REGULATORY OBSERVATION RESOLUTION PLAN RO-UKHPR1000-0049

GDA-REC-GNSL-007911

REGULATO	RY OBSERVATION Resolution Plan
RO Unique No.:	RO-UKHPR1000-0049
RO Title:	Generation, Transport and Behaviour of Tritium During Normal
	Operations
Technical Area(s)	Reactor Chemistry
Revision:	0
Overall RO Closure Date (Planned):	2021-04-30
Linked RQ(s)	RQ-UKHPR1000-0814
Linked RO(s)	RO-UKHPR1000-0026;RO-UKHPR1000-0031
Related Technical Area(s)	Radiological Protection, Radwaste, Decommissioning & Spent Fuel Management, Environmental
Other Related Documentation	
Scope of Work

Fig 1 The Diagram of the Whole Process of Tritium Transport

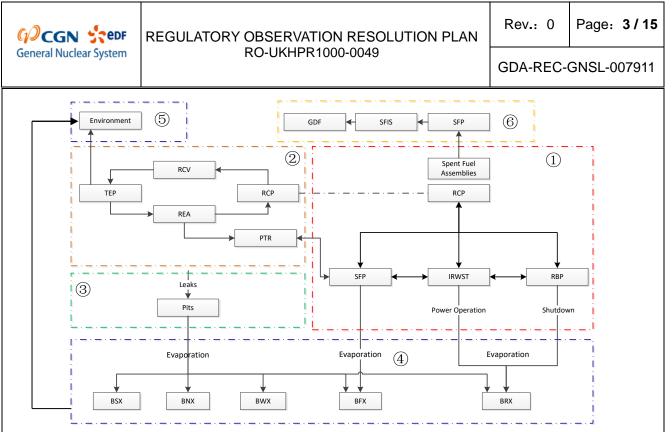
- **ROA1.1:** Provide suitable and sufficient analysis to underpin the claimed generation, transport and behaviour of tritium in the primary circuit and associated systems, and of tritium "leaving" the primary circuit, considering plant-specific aspects of the UK HPR1000 design, such as the use of Enriched Boric Acid and primary coolant recycling. This analysis should quantify and justify the levels of tritium entering other systems in the nuclear island, such as the Spent Fuel Pool and the in-containment refuelling water storage tank (IRWST).

- **ROA1.2:** The analysis should include a consideration of how any operator actions may affect the transport of tritium, and if this results in any additional operating constraints. This analysis should also identify if the generic design imparts any specific constraints on future operators, with respect to the implementation of future tritium management strategies.

The whole process of tritium transport/distribution is illustrated in Fig 1. Based on it, the operational factors that affect the transport of tritium are identified as follows:

- a) Tritium transport in RCP and relevant connected systems (excluding SFP, IRWST and RBP) (2), is affected by the tritium management strategy, the boron recycling strategy and to a lesser extent to the failed fuel management strategy;

- b) For tritium transported to SFP, IRWST and RBP (①), **the head-lift limit or target value** affects the amount of tritium entering into these pools. Other operational factors, e.g. the boron recycling strategy, have a minor impact on tritium concentration in these water bodies.

- c) With respect to tritium transport to building atmosphere (③ and ④), the strategy for managing leaks (which influences leak rate and duration), the tritium concentration in the leaking system and the water bodies (cf. bullet points a) and b) above), the SFP temperature management strategy can affect the amount of tritium entering into the buildings' atmosphere.

- d) With respect to discharges (⑤), the **buffer storage time** of liquid waste before discharge can affect the discharge of liquid tritium. However, since tritium has a relative long half-life, this influence is negligible. For gaseous discharges, everything that can affect tritium concentration in the building atmosphere will affect gaseous discharges of tritium.
